Better Housing by Design:

An update to Portland's Multi-Dwelling Zoning Code

Work Session #7

April 9, 2019

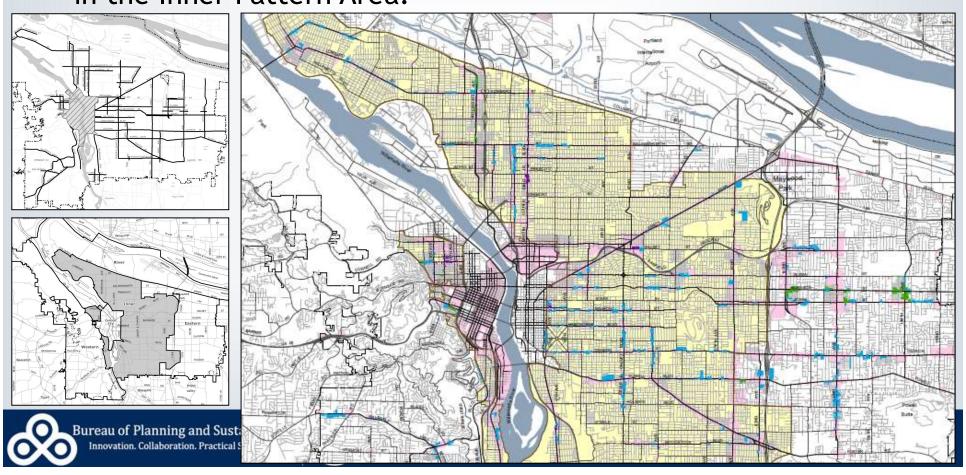
11-12. Allow for no setbacks between properties in multi-dwelling zones (RM2-RM4) on major corridors and abutting mixed use zones. Apply this allowance to Civic and Neighborhood corridors in the Inner Pattern Area.

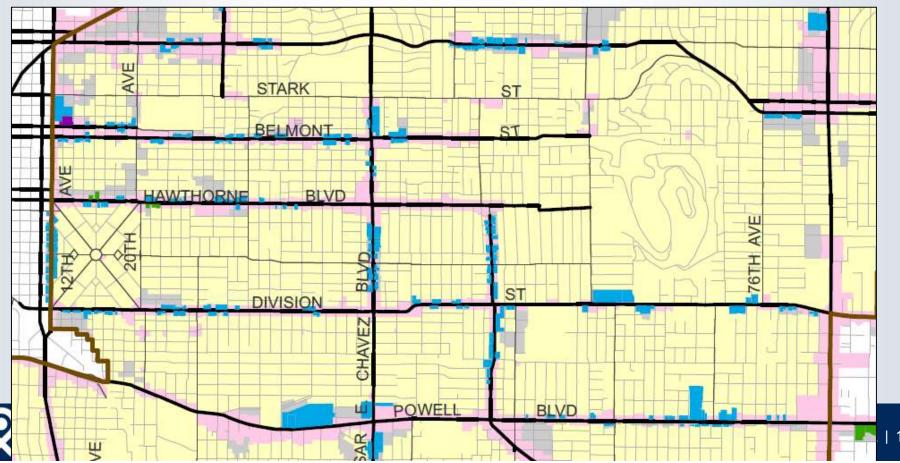
11-12. Allow for no setbacks between properties in multi-dwelling zones (RM2-RM4) on major corridors and abutting mixed use zones. Apply this allowance to Civic and Neighborhood corridors in the Inner Pattern Area.

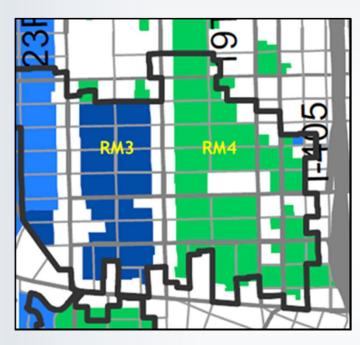
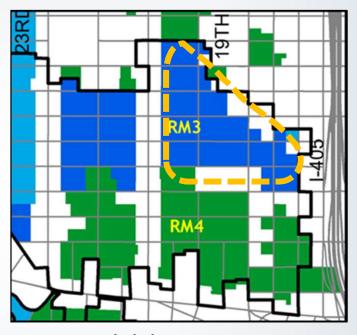
- (1) Apply RM4 zoning between NW 21st & NW 23rd south of Glisan/Hoyt
- (2) Apply RM3 zoning east of NW 21st north of Glisan/Hoyt

2C: For the King's Hill Historic District, Reassign RM4 & RM3 Zoning at its Southern Edges to Reflect Development Patterns

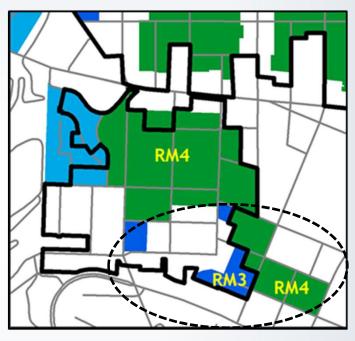
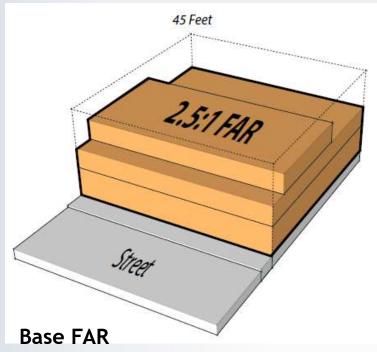
- (1) Apply RM3 zoning to properties in the historic district with small historic structures at southern edge
- (2) Apply RM4 zoning to 3-block area east of the historic district

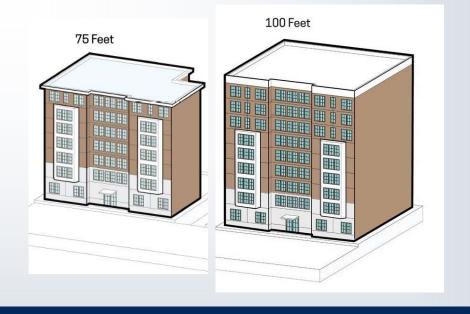
8. Continue to allow 100' building height in the RM4 zone within 1000' of light rail stations (including in historic districts)

Expand the 100' building height allowance in the RM4 zone to also apply within 500' of frequent transit lines (outside historic districts)

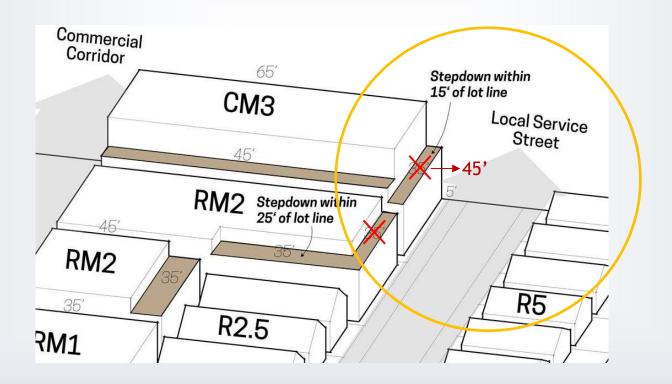
Change step-height across a local service street from single-dwelling zones to 45' (instead of 35'), in both multi-dwelling and single dwelling zones

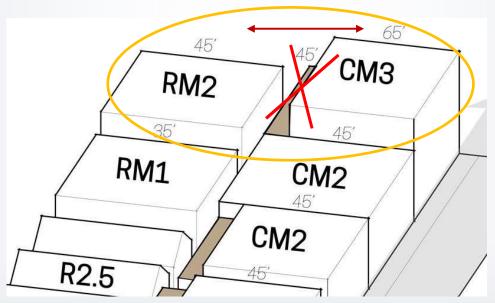
No step down required between CM3 and RM2
